HISTORIC LANDMARK COMMISSION

STAFF REPORT

New Single Family Dwelling New Construction PLNHLC2014-00730 and PLNHLC2014-00628 757 North Wall Street

Meeting Date: November 6, 2014

Defined Yard Areas

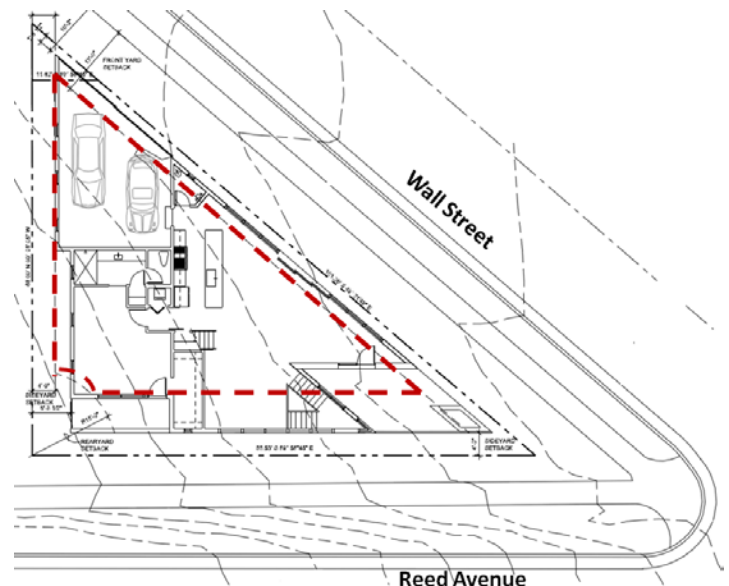
Based upon the non-standard shape of the property, staff has determined that the Wall Street side is the front yard, the Reed Avenue side is a corner side yard, the west property line is the interior side yard, and the intersection of the interior side yard and corner side yard is defined as the rear yard.

Current Site Plan Showing Location of Required Setbacks

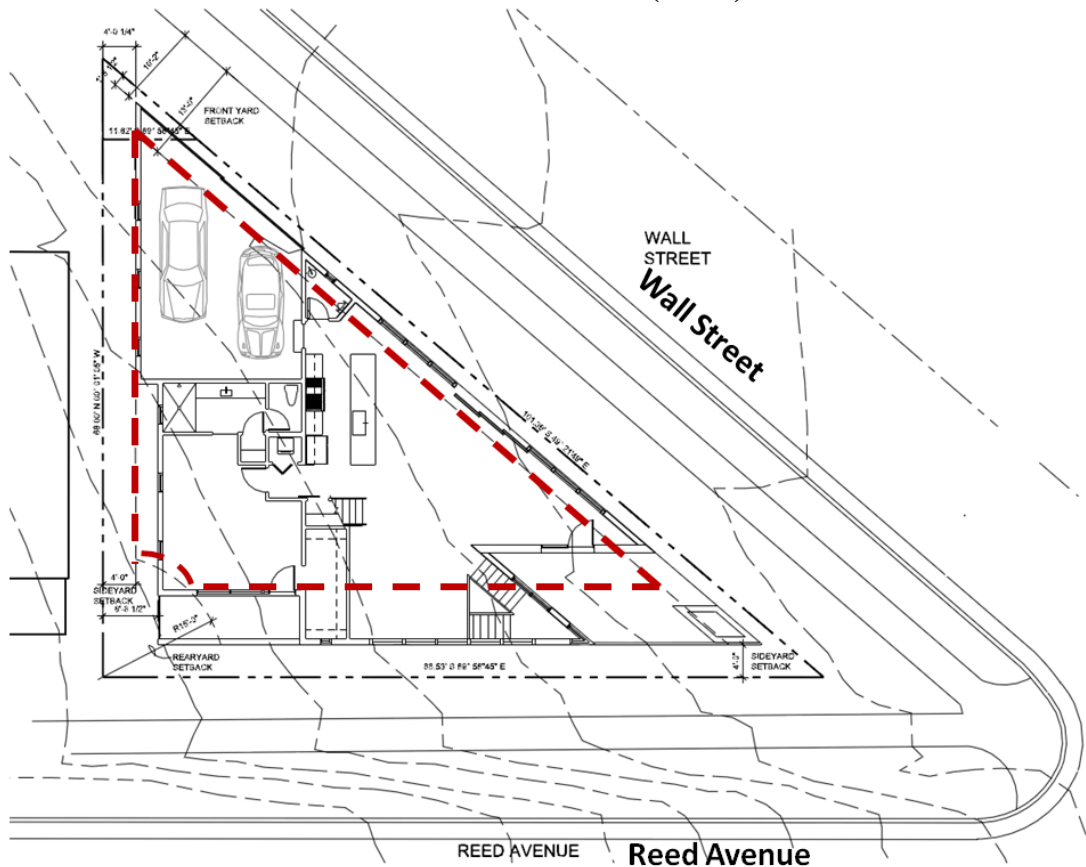
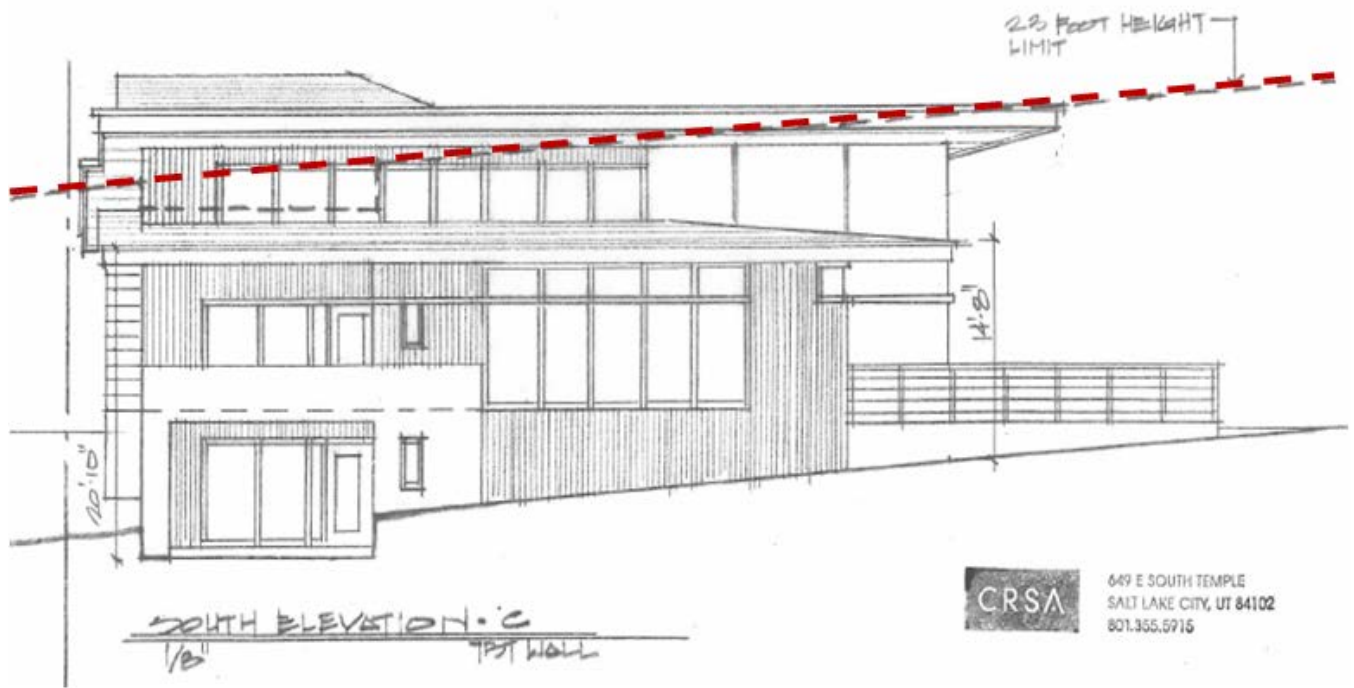
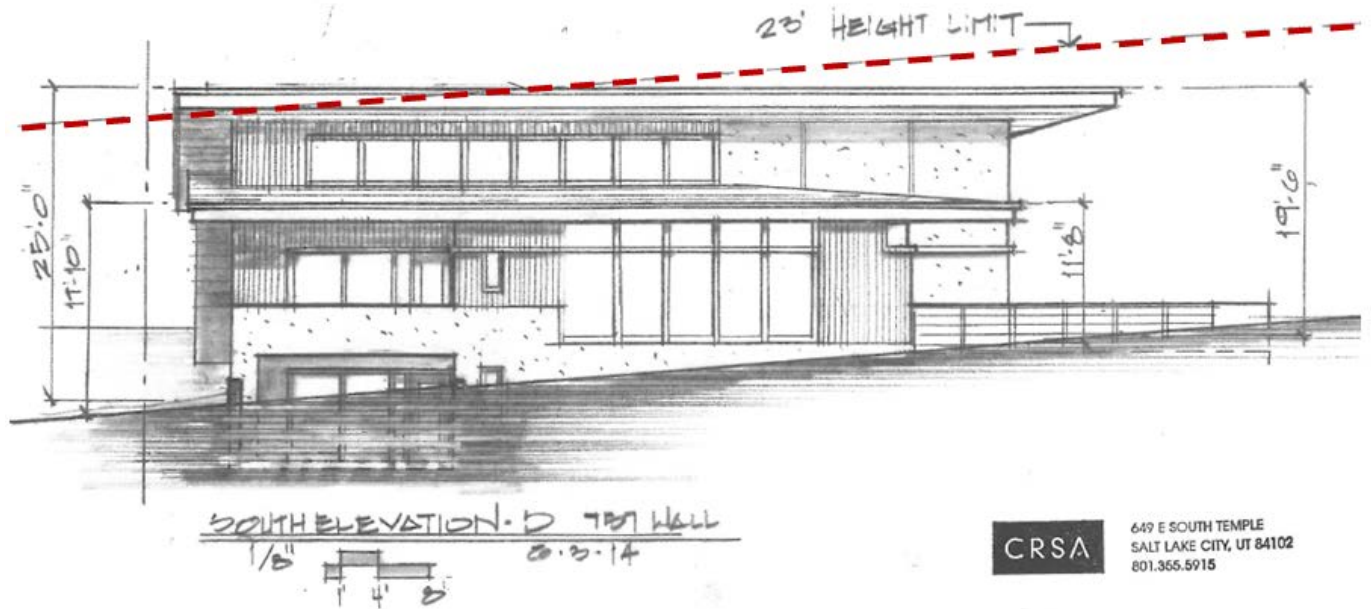
Analysis: The proposed street setbacks have not been changed since the initial proposal. The home will be constructed closer to the sidewalk than other homes along either block face. This is primarily driven by the shape and undersized character of the parcel. The home immediately to the west along Reed Avenue is setback 4 feet from the property line and the other setbacks generally increase as you continue westward. Along Wall Street, some homes are as close as 7 feet from the property line. Based upon averaging the block faces, the ordinance would normally require a 10.5 foot setback along Reed Avenue and a 13 foot setback along Wall Street. This proposal is for a 3 foot setback along both street frontages.

The previously proposed reduced interior side yard setback between the house immediately to the west and the proposed home was of concern when this project was initially reviewed by the Historic Landmarks Commission. To address this issue, the applicant has modified the plans to meet the interior side yard setback (four feet), and lowered the height of the home by two feet. These changes will lower the impact to the neighboring property and is compatible with the traditional setbacks found within the neighborhood.

- Our new proposal moves the home one foot east to meet the 4-foot side yard setback
- We lowered the roof three feet. Now, 90% of the structure is at or below the required 23-foot height restriction with the southwest corner at approximately 25-feet, due to the natural slope of the property.

Current Proposal--South Elevation and 23 Foot Height Standard

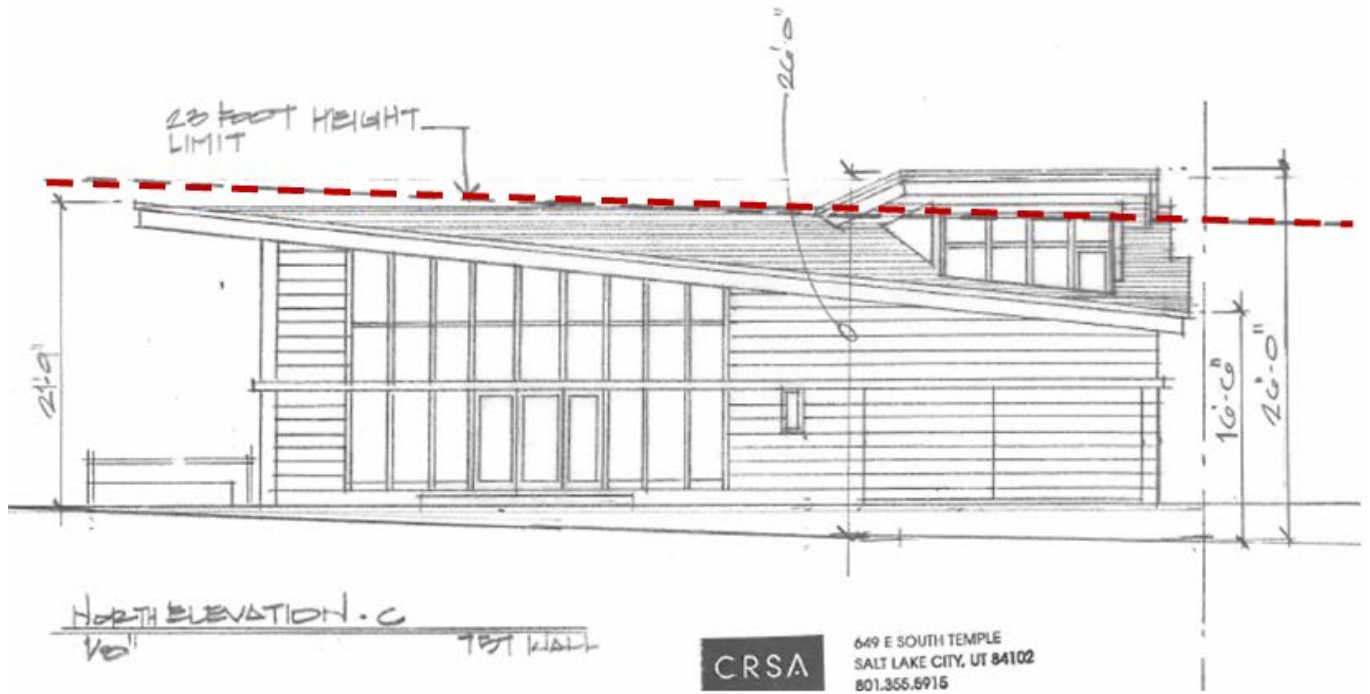
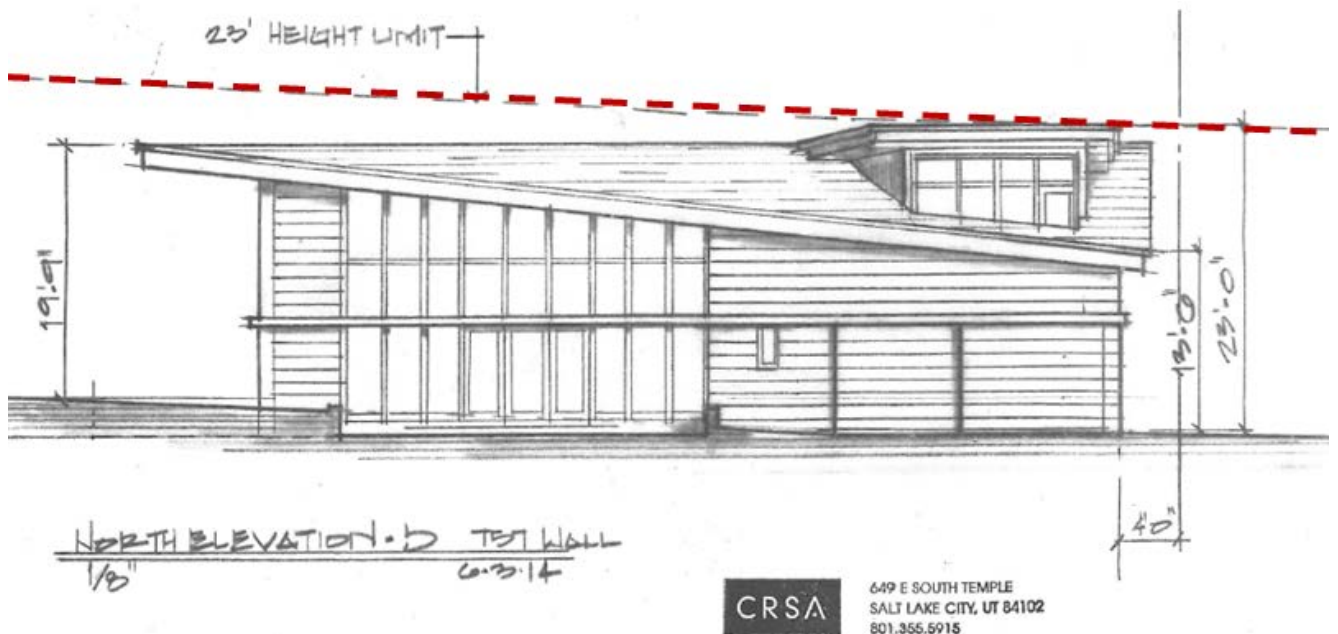
The applicant is also seeking approximately two feet of additional building height. This is necessitated by the slope of the property and will be most predominate on the southwest corner. The additional height will be negligible on the Wall Street frontage and less of a concern as it is adjoining the neighboring properties rear yard. The home immediately west of this property is 22 feet tall and there are several between 23 and 24 feet in height across the street. As is typical in the Capitol Hill District, there is an eclectic mix of home sizes in the area. As the majority of the home will be below the 23 foot limit, staff believes that the additional height will not negatively affect the neighborhood.
